August 17, 2012 (Revised September 20, 2012)

Subject: CSO 058 Separation Project  
Project Elimination  
IOAP Project No. L\_OR\_MF\_058\_S\_08\_A\_A\_0  
DOJ Case No. 90-5-1-1-08254

# CSO LTCP Project Fact Sheet

Ohio River  
Solution ID # L\_OR\_MF\_058\_S\_08\_A\_A  
CSO058 Sewer Separation

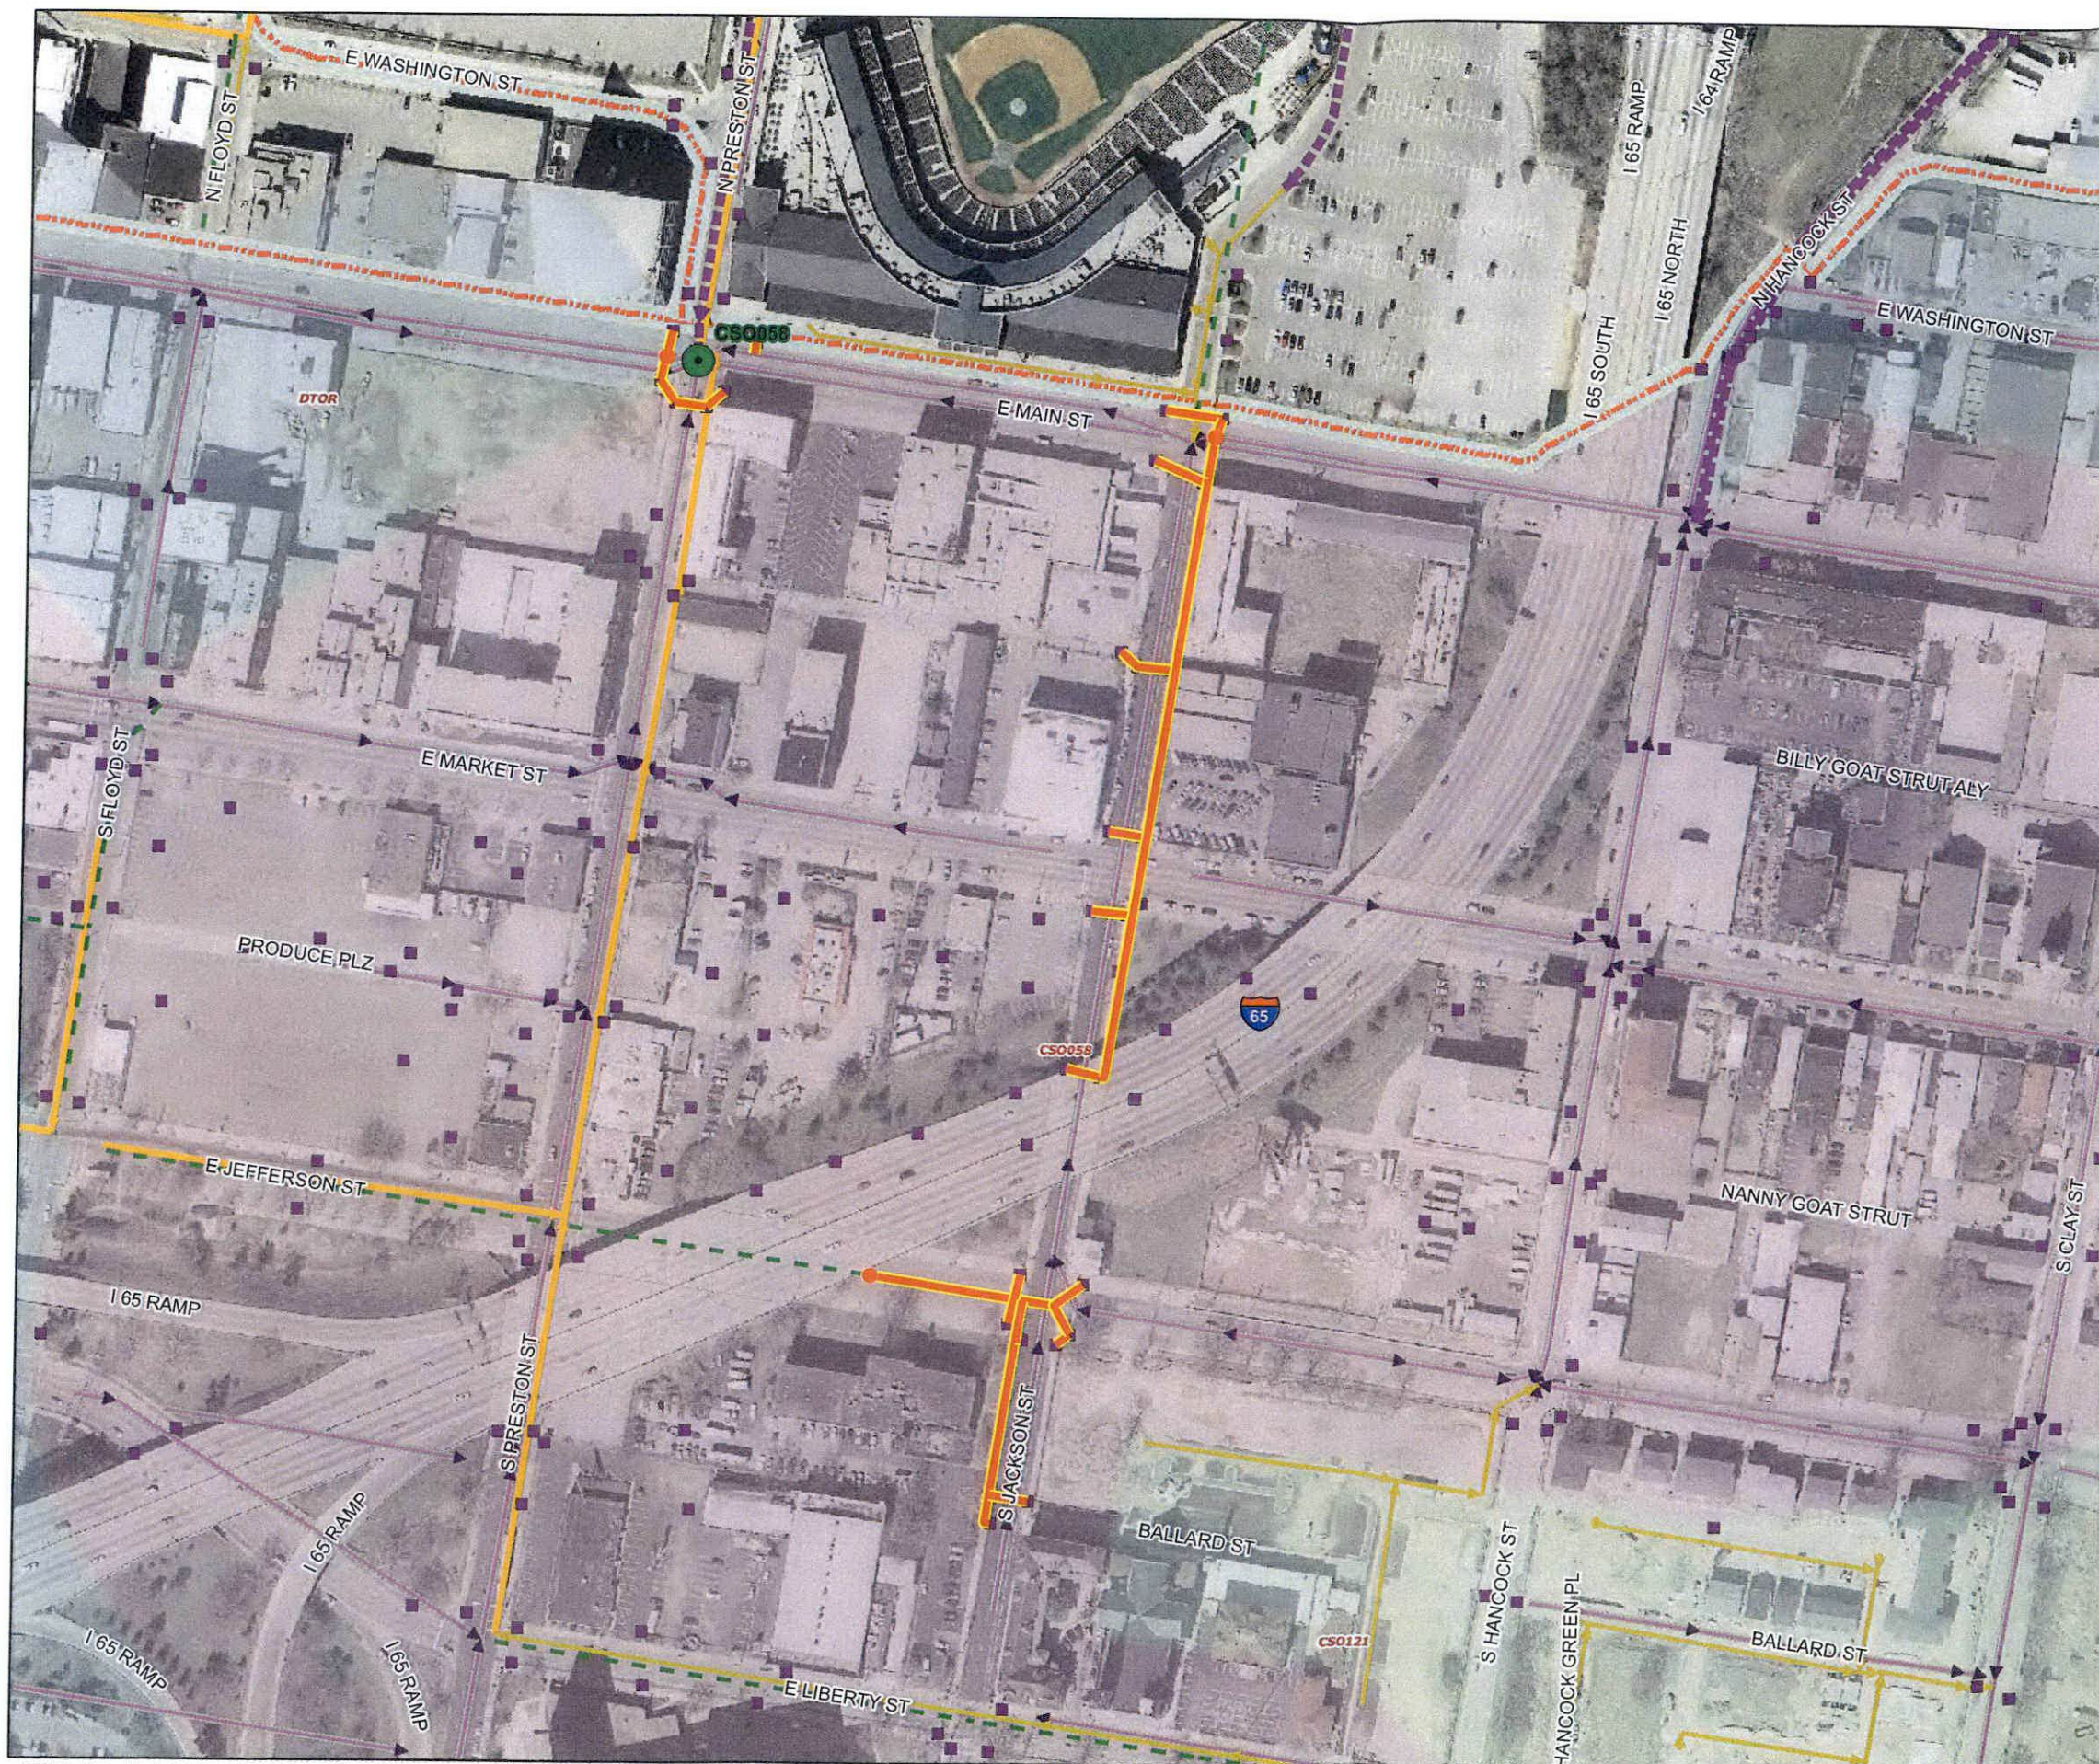
The project modification involves the elimination of this project, as other proposed project changes related to the proposed 13<sup>th</sup> and Rowan Street Basin has made the separation unnecessary. Based on benefit/cost analysis, the level of control will be changed from zero to eight CSO events in a typical year. Note however that the original sewer separation project would have allowed "first flush" urban stormwater runoff to reach the Waters of the US with virtually every rain event. It is likely that capturing first flush stormwater runoff and allowing combined sewage to overflow only eight times in a typical year represents an improvement in capture of contaminant loadings as compared to sewer separation.

Reviews of project approach and benefit/cost results indicate that the elimination of the CSO 058 Sewer Separation is justified. The consolidation of its storage volume in the 13<sup>th</sup> Street and Rowan Street Storage Basin (IOAP Project No. L\_OR\_MF\_155\_M\_09B\_B\_B\_4) has proven to be a more cost-effective option than the original design for two separate projects.

Details on the modification of the 13<sup>th</sup> Street and Rowan Street Storage Basin to compensate for the consolidation of flows from the CSO 058 Sewer Separation are available in the 13<sup>th</sup> Street and Rowan Street Storage Basin project modification letter. This consolidated project will include a modification of the completion date to December 31, 2020.

For your reference, copies of the original project fact sheet and map from the 2009 IOAP have been provided in Attachment A. A revised project fact sheet and map is attached to the 13<sup>th</sup> Street and Rowan Street Storage Basin modification letter reflecting the new project size and conveyance alignment.
